PG&E Letter DCL-15-095

Response to NRC Request for Additional Information Regarding Recommendation 2.1  
of the Near-Term Task Force Seismic Hazard and Screening Report

## Response to NRC Request for Additional Information Regarding Seismic Hazard and Screening Report

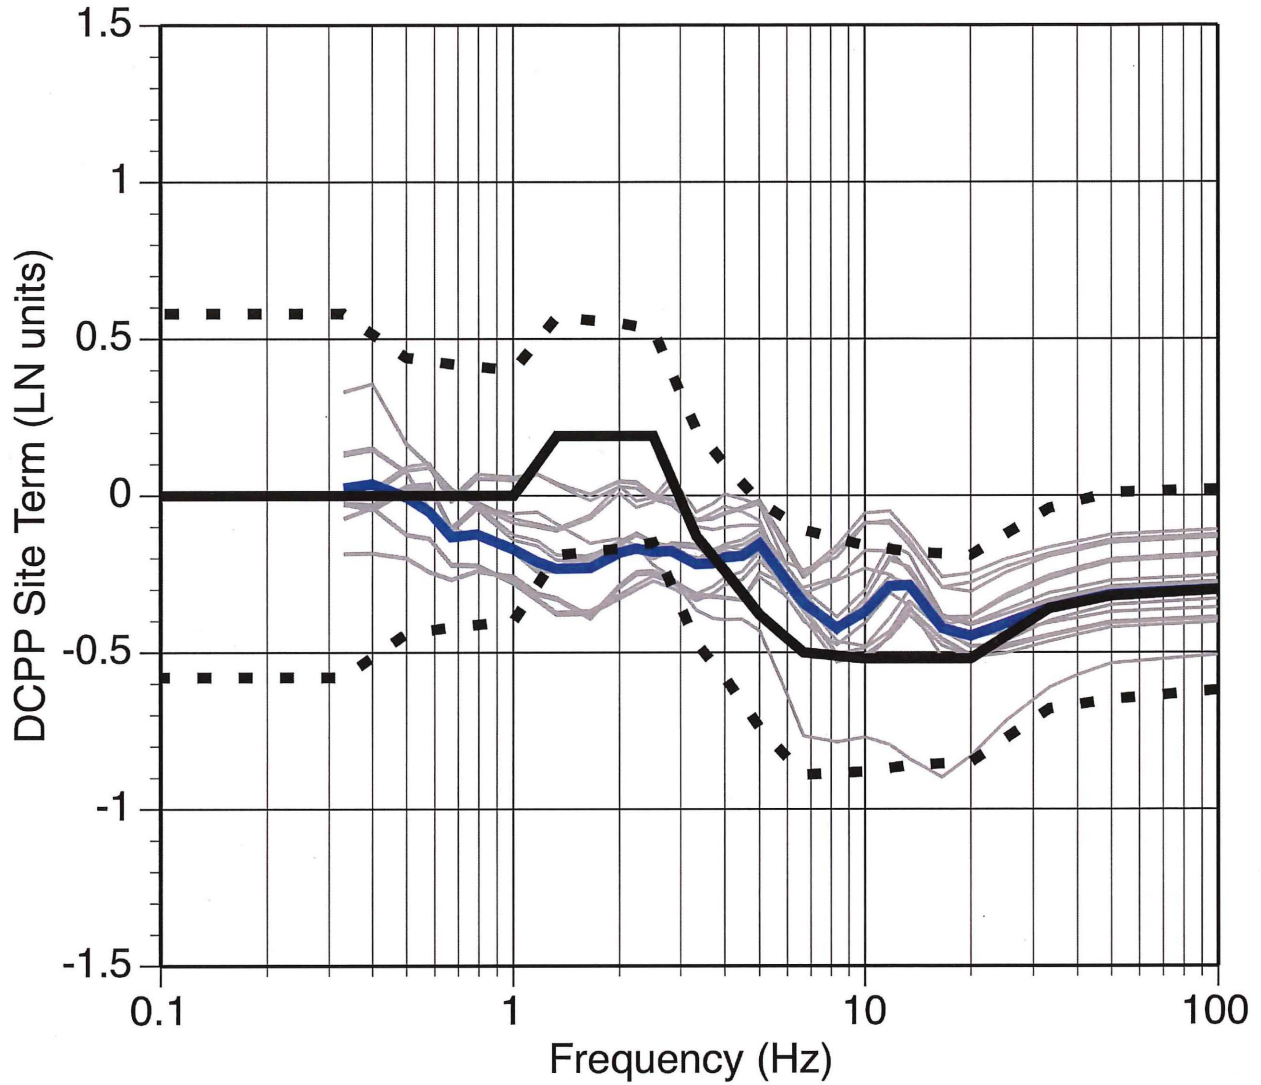
Consistent with the request for information issued pursuant to Title 10 of the Code of Federal Regulations, Part 50, Section 50.54(f) and the Screening Prioritization and Implementation Details (SPID) guidance, a supplemental response to the March 2015 seismic hazard reevaluation that develops site amplification factors as recommended in Section 2.4 and Appendix B of the SPID is requested. Please provide (1) a detailed description of the subsurface profile properties including uncertainties, (2) the potential for nonlinear behavior at the strain levels produced by the scenario earthquakes of interest, and (3) the control point elevation. In addition, provide the adjustment factors (VS-kappa corrections) needed to modify the median ground motion models for the selected reference or baserock elevation and velocity. Also include in the response, as a figure and a table, control point seismic hazard curves developed using the site amplification factors and their uncertainties through the hazard integral as recommended in Appendix B of the SPID.

A comparison of the resulting site amplifications from the analytical modeling approach and the empirical data approach is shown in Figure 1. The black curves show the mean and range of the empirical site terms used in the March 2015 submittal. The blue curve shows the mean amplification from the analytical modeling for a kappa of 0.040 seconds (sec) for a reference rock peak acceleration of 0.1g that is representative of the linear response range which is consistent with the level of shaking from the empirical data used to compute the empirical site terms. The gray curves show range of the amplification for different assumptions of the velocity profile and the nonlinear site parameters for a kappa of 0.040 sec. These alternative cases are described in detail in the response to the questions.

Figure 1 shows that the site terms from empirical model are generally consistent with the site terms from the analytical modeling for the high frequencies. Stronger resonances are seen in the analytical model results (e.g., 12 hertz (Hz)) which is a

common feature of site response based on 1-D velocity models. At the 1-3 Hz range, the analytical modeling leads to lower amplification than the empirical model because the shallow velocity model used in the analytical modeling does not capture the effects of the site-specific deep velocity profile, whereas, the empirical model captures the effects of the full velocity profile.

The analytical model described in the response to the questions also includes a broad uncertainty in the site kappa value, which leads to a broader range of amplifications in the high frequency range than shown in Figure 1. The uncertainty range with kappa is much broader than the uncertainty range from the empirical approach. This shows the value of using observed ground motions over assumed parameter distributions from generic correlations. Because the large amplification that results from the lower kappa value is not seen in the recorded ground motions at DCPP, the lower kappa value (0.024 sec) is not consistent with the observed ground motions. The broad uncertainty range for kappa is included in the response to the questions to be consistent with the SPID methodology. However, based on the high frequency content of the observed ground motions at DCPP, PG&E considers the low kappa value to be not applicable to DCPP. The high kappa value of 0.07 sec is also inconsistent with the frequency content of the recorded ground motions at DCPP.

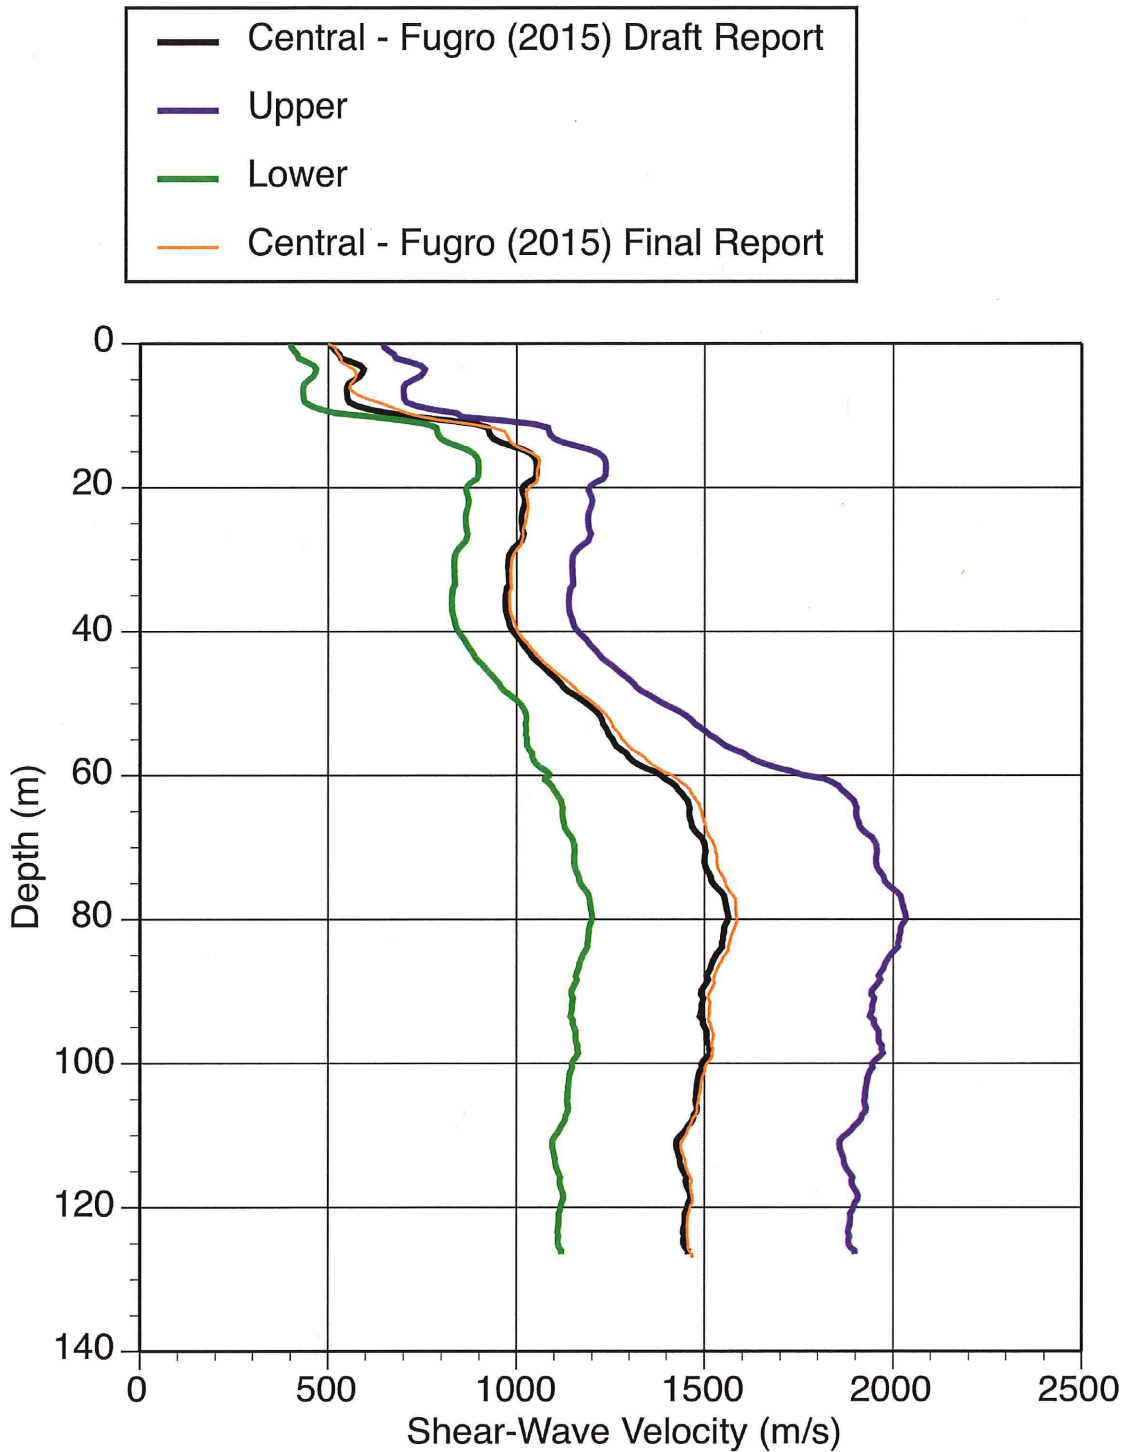
Please provide a detailed description of the subsurface profile properties including uncertainties.

For the Free-Field Seismic Instrument Control Point (ESTA28, Elevation 85 ft), the VS profile was developed using a representative 1-D profile from the 3-D model (given in Appendix H of Reference 3). The uncertainty in the 3-D velocity model was also addressed in Reference 3 (Section 3) and the recommended uncertainty range is listed in Table 1-1 below. Using this uncertainty estimate, the epistemic uncertainty in the VS profile at ESTA28 was developed using plus or minus 1.6 times the standard deviation (approximates the 5<sup>th</sup> to 95<sup>th</sup> fractile for the uncertainty) at all depths. The three alternative base velocity profiles for the shallow part of the profile (to a depth of 126 meters (m)) are plotted in Figure 1-1 below. Because these profiles represent the 5 to 95 percent range, the logic tree weights are 0.6 for the central model and 0.2 each for the upper and lower models.
